EPC STORMWATER REVIEW COMMENTS ARE SHOWN IN ORANGE BOXES WITH BLACK TEXT

# PAINT BRUSH HILLS METROPOLITAN DISTRICT SCENIC VIEW AT PAINT BRUSH HILLS POND MODIFICATIONS

MAY 2022

SCENIC VIEW AT PAINT BRUSH HILLS POND MODIFICATIONS, RGA PROJECT NO. 1070.0022

DRAWN BY:	DESIGNED BY:
JGS	GEW
JOB NUMBER:	1070.0022
DATE:	MAY 2022
SCALE:	1" = 20'
DRAWING NAME:	EROSION CONTROL
SHEET NO.:	6 of 8

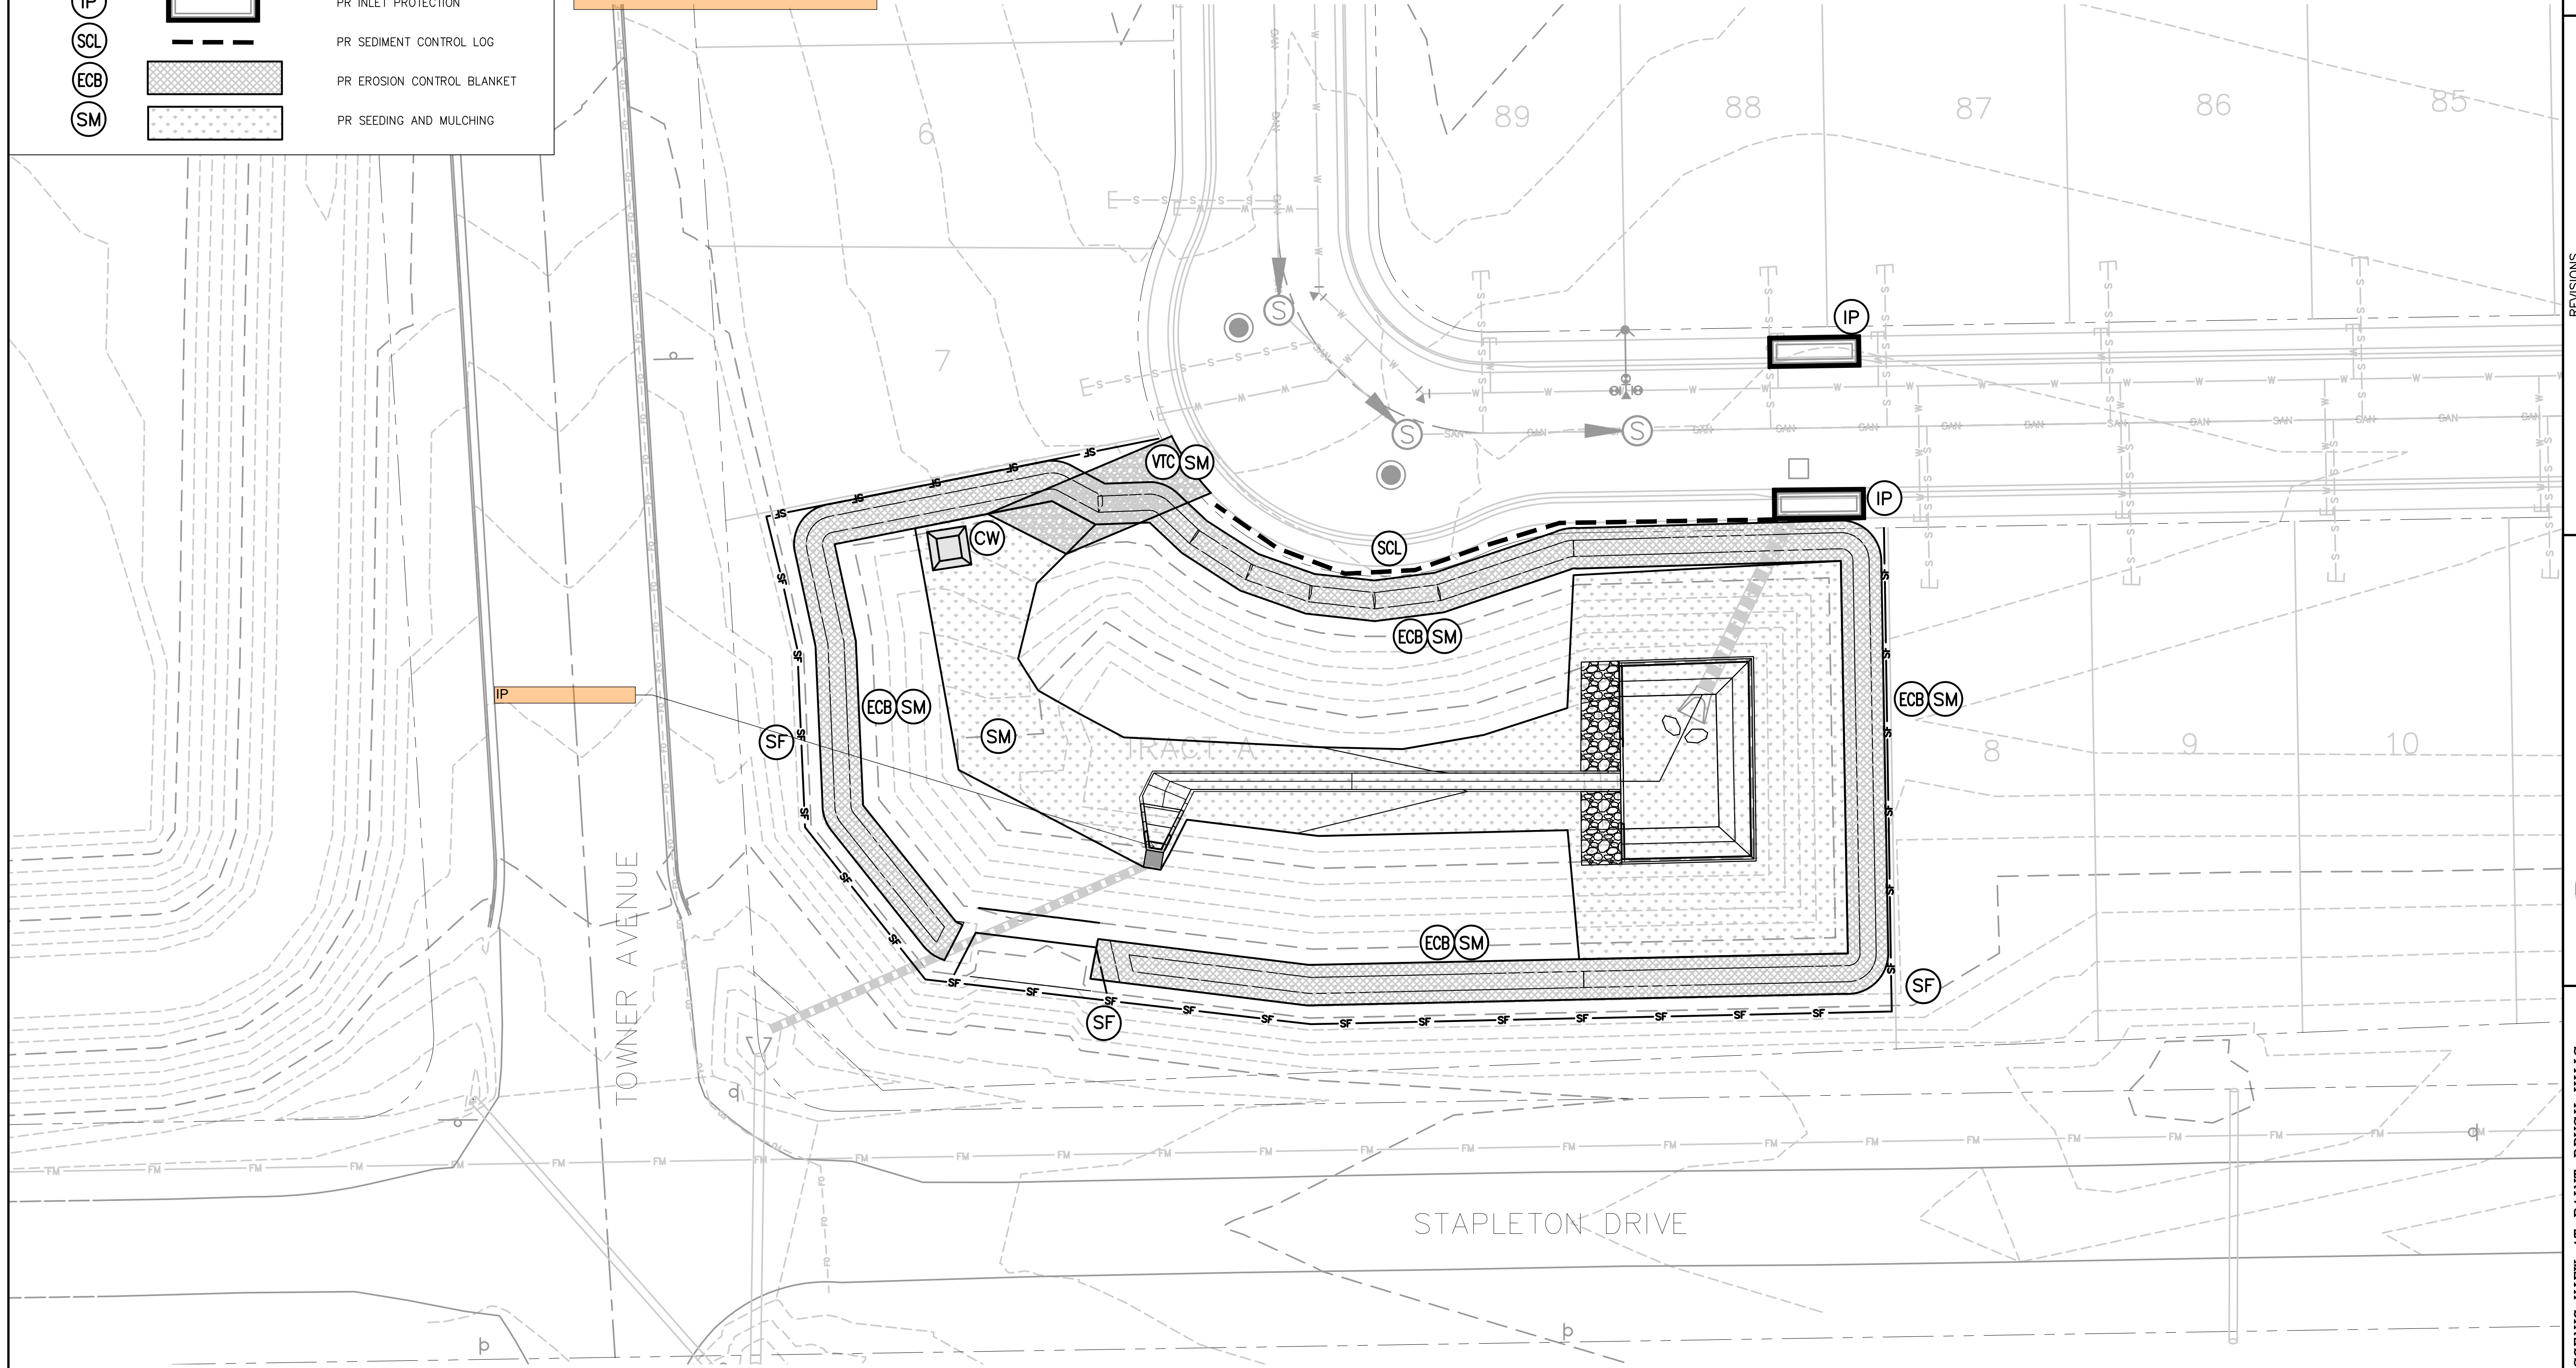
All proposed temporary construction control measures, structural and non-structural. Temporary construction control measures shall be identified by phase of implementation to include "initial," "interim," and "final" or shown on separate phased maps identifying each phase
